CITY OF CELINA, TEXAS ORDINANCE NO. 2019-09

AN ORDINANCE OF THE CITY OF CELINA, TEXAS AMENDING THE CITY'S CODE OF ORDINANCES; CHAPTER 3: BUILDING REGULATIONS; DIVISION 1 GENERALLY SECTION 3.02.001 ENFORCEMENT; ADD SECTION 3.02.003 ADOPTION BY REFERENCE; DIVISION 2 BUILDING CODE; SECTION 3.02.051 INTERNATIONAL BUILDING CODE WITH AMENDMENTS; DIVISION 3 FIRE CODE; SECTION 3.02.101 INTERNATIONAL FIRE CODE WITH AMENDMENTS; DIVISION 4 RESIDENTIAL CODE; SECTION 3.02.151 INTERNATIONAL RESIDENTIAL CODE WITH AMENDMENTS; DIVISION 5 MECHANICAL CODE; SECTION 3.02.201 INTERNATIONAL MECHANICAL CODE WITH AMENDMENTS; DIVISION 6 FUEL GAS CODE; SECTION 3.02.251 INTERNATIONAL FUEL GAS CODE WITH AMENDMENTS; DIVISION 7 PLUMBING CODE; SECTION 3.02.301 INTERNATIONAL PLUMBING CODE WITH AMENDMENTS; DIVISION 8 NATIONAL ELECTRICAL CODE; SECTION 3.02.351 NATIONAL ELECTRIC CODE WITH AMENDMENTS; DIVISION 9 ENERGY CONSERVATION CODE; SECTION 3.02.401 INTERNATIONAL ENERGY CONSERVATION CODE WITH AMENDMENTS; DIVISION 10 PROPERTY MAINTENANCE CODE; SECTION 3.02.451 INTERNATIONAL PROPERTY MAINTENANCE CODE WITH AMENDMENTS; DIVISION 11 SWIMMING POOL AND SPA CODE; SECTION 3.02.501 INTERNATIONAL SWIMMING POOL SPA CODE WITH

Figure R602.6.1; delete the figure and insert the following figure:

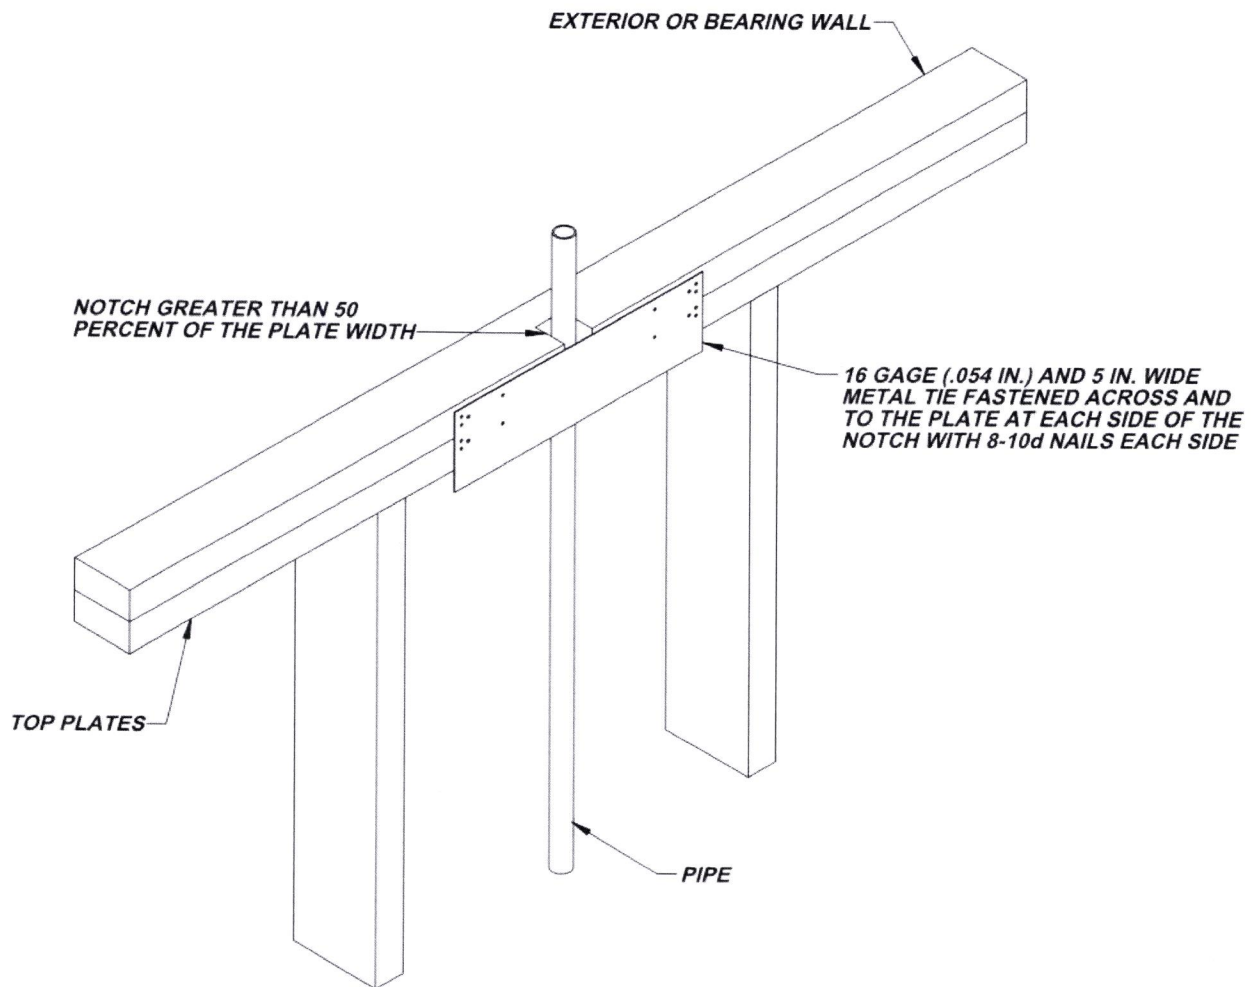
Section 602.6.1; amend the following:

R602.6.1 Drilling and notching of top plate. When piping or ductwork is placed in or partly in an exterior wall or interior load-bearing wall, necessitating cutting, drilling or notching of the top plate by more than 50 percent of its width, a galvanized metal tie not less than 0.054 inch thick (1.37 mm) (16 Ga) and ~~1 1/2 inches (38 mm)~~ 5 inches (127 mm) wide shall be fastened across and to the plate at each side of the opening with not less than eight 10d (0.148 inch diameter) having a minimum length of 1 1/2 inches (38 mm) at each side or equivalent. Fasteners will be offset to prevent splitting of the top plate material. The metal tie must extend a minimum of 6 inches past the opening. See figure R602.6.1. {Remainder unchanged}
